Access Compliance Report

Public Rights-of-Way

(Pedestrian Signals)

Intersection ID: N/A	Main Street:	Cross Street: N/A	Location: N/A
ADA ID: 30E822D54251	Signal Type: Two Push Buttons-Non APS	Overall Compliance: No	Severity Score: BTN 1:N/A BTN 2: N/A No BTN: N/A
Codes/Mitigation Info/Possible Solution		Field Measurements/Component Compliance

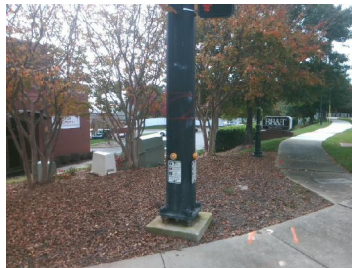
Compliance	Description	Data	Compliance	Description	Data
	Button Count	Button2	N/A	Distant to Additional Button (in)	N/A
	Additional Button Present?	No		Additional Button ID	N/A
N/A	Signal Buttons Required?	N/A	N/A	Additional Ped Posts Required	N/A
	How Many Ped Street Xings?	2		Located In An Island/Median?	No
N/A	B 1 Sign Present?	Yes	N/A	B 2 Sign Present?	Yes
Yes	B 1 Sign Purpose?	Yes	Yes	B 2 Sign Purpose?	Yes
Yes	B 1 Sign Lettering & Contrast?	Yes	Yes	B 2 Sign Lettering & Contrast?	Yes
Yes	B 1 Parallel To XWalk?	Yes	Yes	B 2 Parallel To XWalk?	Yes
Yes	B 1 PAR to Button?	Yes	Yes	B 2 PAR to Button?	Yes
Yes	B 1 PAR to XWalk?	Yes	Yes	B 2 PAR to XWalk?	Yes
Yes	B 1 Clear Floor Space?	Yes	Yes	B 2 Clear Floor Space?	Yes
N/A	B 1 FWD Approach?	Yes	N/A	B 2 FWD Approach?	Yes
N/A	B 1 FWD Approach Constrained?	No	N/A	B 2 FWD Approach Constrained?	No
No	B 1 FWD Approach Reach (in)	21.0	No	B 2 FWD Approach Reach (in)	21.0

N/A	B 1 FWD Approach Width (in)	N/A	N/A	B 2 FWD Approach Width (in)	N/A
N/A	B 1 FWD Approach Obstruction?	Yes	N/A	B 2 FWD Approach Obstruction?	Yes
N/A	B 1 FWD Approach Obstruction Dist (in)	21.0	N/A	B 2 FWD Approach ObstructionDist (in)	21.0
N/A	B 1 PARA Approach?	Yes	N/A	B 2 PARA Approach?	Yes
N/A	B 1 PARA Approach Constrained?	No	N/A	B 2 PARA Approach Constrained?	No
No	B 1 PARA Approach Reach (in)	13.0	No	B 2 PARA Approach Reach (in)	13.0
N/A	B 1 PARA Approach Width (in)	N/A	N/A	B 2 PARA Approach Width (in)	N/A
N/A	B 1 PARA Approach Obstruction?	Yes	N/A	B 2 PARA Approach Obstruction?	Yes
N/A	B 1 PARA Approach Obstruction Dist (in)	13.0	N/A	B 2 PARA Approach ObstructionDist (in)	13.0
Yes	B 1 Clear Floor Space Slope (%)	0.9	Yes	B 2 Clear Floor Space Slope (%)	3.5
Yes	B 1 Clear Floor Space XSlope (%)	0.9	Yes	B 2 Clear Floor Space XSlope (%)	0.6
N/A	B 1 PAR Slope (%)	0.8	N/A	B 2 PAR Slope (%)	5.3
Yes	B 1 Height (in)	43.0	Yes	B 2 Height (in)	42.5

Yes	B 1 Clear Xing Direction?	ClearlyMarked	Yes	B 2 Clear Xing Direction?	ClearlyMarked
	B 1 Crossing Direction	To NE		B 2 Crossing Direction	To NW
Yes	B 1 DistanceTo XWalk (in)	0.0	Yes	B 2 DistanceTo XWalk (in)	0.0
No	B 1 DistanceTo Curb (in)	194.0	No	B 2 DistanceTo Curb (in)	217.0
Yes	B 1 Diameter (in)	2.0	Yes	B 2 Diameter (in)	2.0

Possible Solutions: Replace Signal Push Button With APS Button on New Post. Remove & Relocate Sign.

PROW/ADA: TMUTCD 4e.08, R406.2, R404.7.3
